No.	ZONE	REVISIONS	BY	DATE
		ADDENDUM NO. 2		10/12

CITY OF SAUSALITO PRIORITY 1 SEWER REPLACEMENT PROJECT 1B
HUMBOLDT AVENUE IMPROVEMENT PLAN AND DETAILS

JOB NUMBER	454-02-09-02
DRAWING NUMBER	C01
SHEET NUMBER	4 OF 28
REVISION

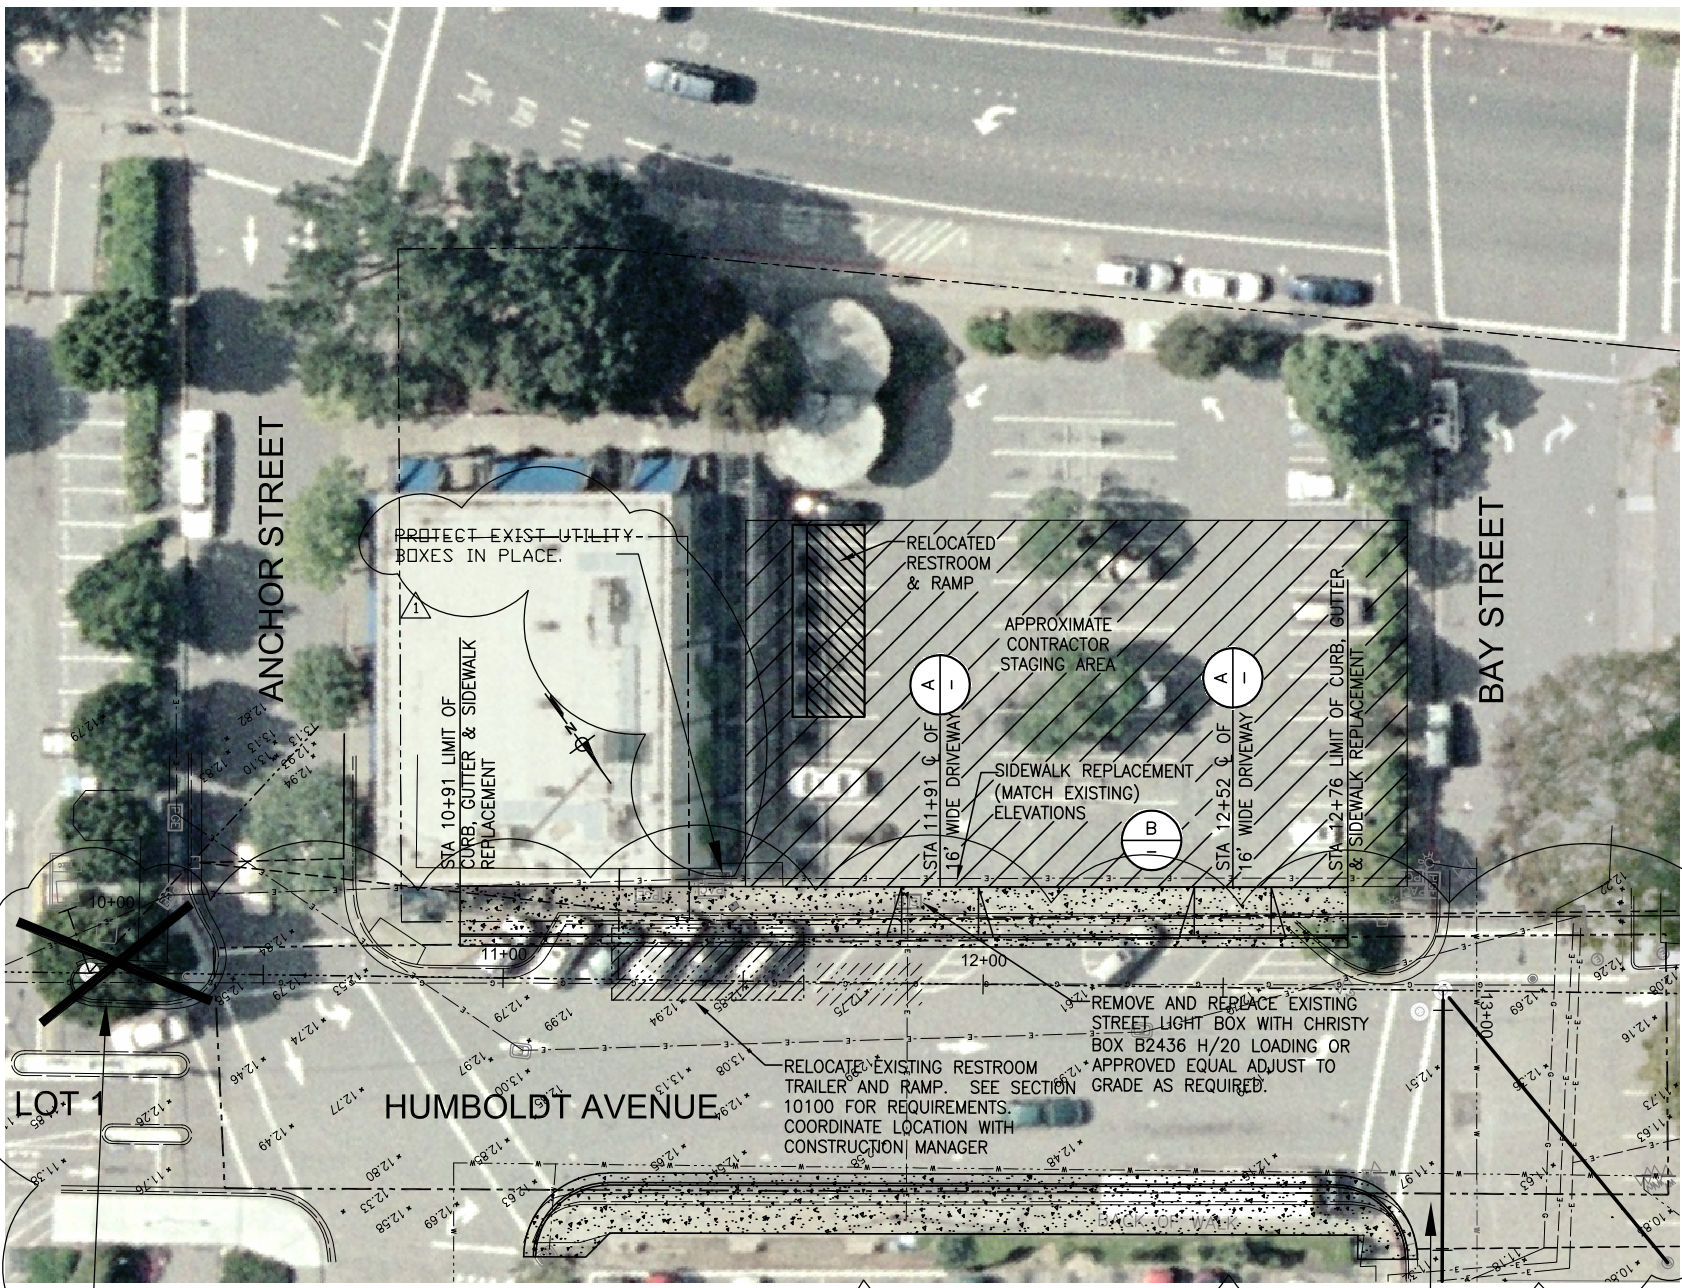
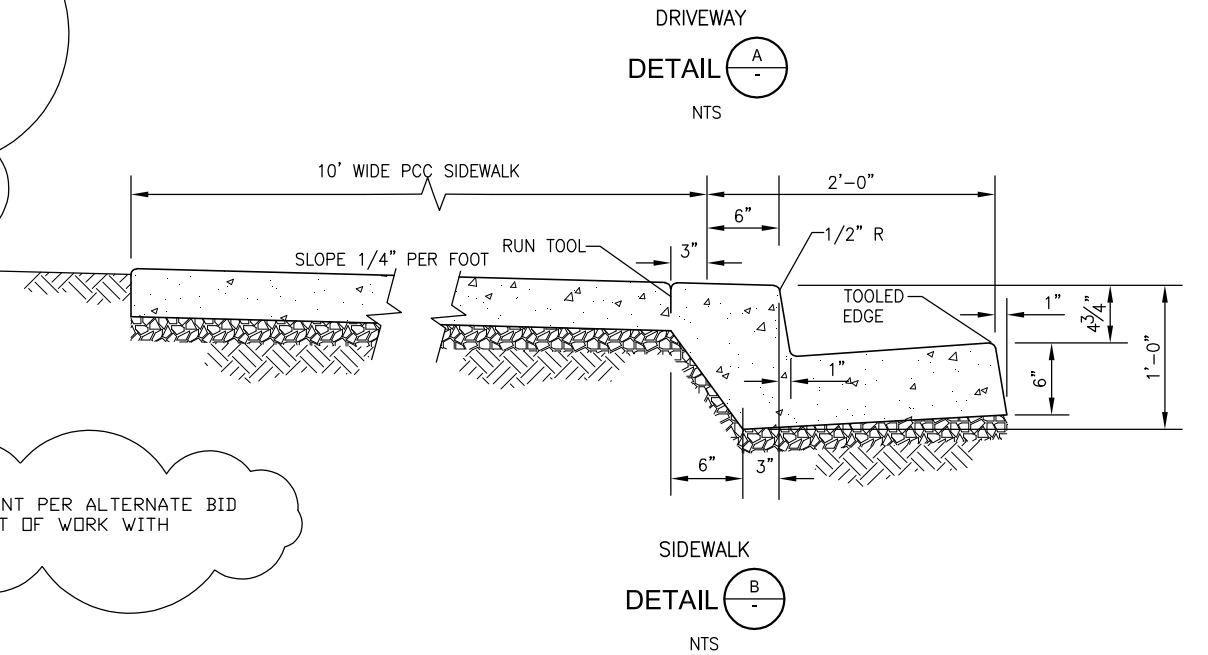
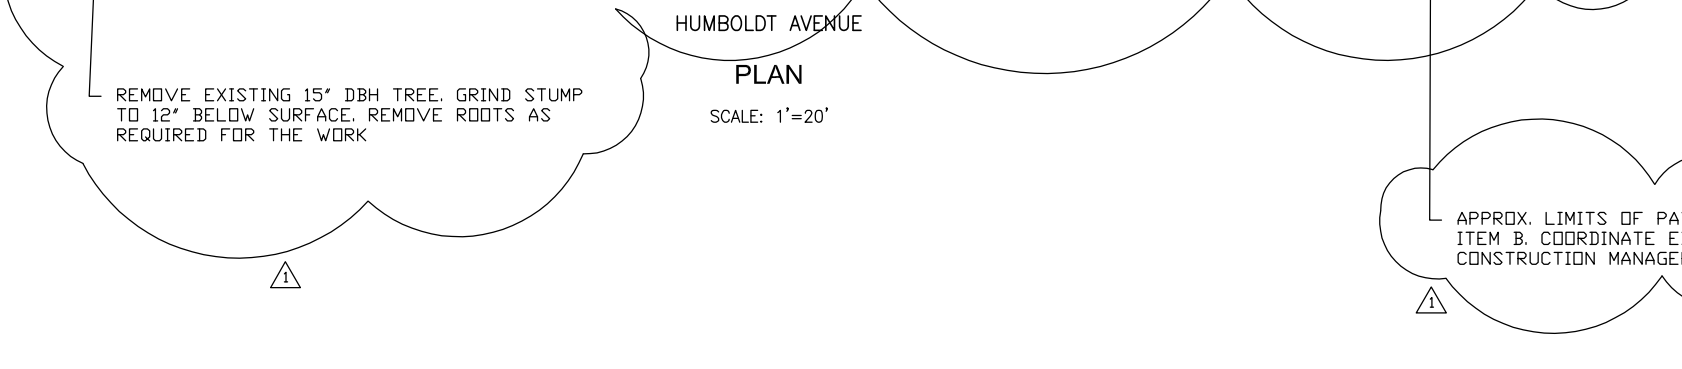
- NOTES:
1. REMOVE APPROXIMATE 400 LF (E) CURB, GUTTER, SIDEWALK, AND DRIVEWAY. REPLACE WITH NEW 10' WIDE SIDEWALK, CURB, GUTTER, AND DRIVEWAY ON BOTH SIDES OF HUMBOLDT AVENUE BETWEEN ANCHOR AND BAY AND BETWEEN SPINNAKER AND BAY. ADJUST STREET GRADES AS NEEDED. NEW THERMOPLASTIC PAVEMENT MARKINGS AS DIRECTED.
 2. COORDINATE STAGING AREA WITH ON-GOING DOWNTOWN RESTROOM PROJECT.
 3. MAINTAIN ACCESS TO PARKING LOT 2 FOR THE DOWNTOWN RESTROOM PROJECT CONTRACTOR AND FOR PUBLIC ACCESS TO THE RELOCATED RESTROOM

APPROX. LIMITS OF PAVEMENT PER ALTERNATE BID ITEM B. COORDINATE EXTENT OF WORK WITH CONSTRUCTION MANAGER.
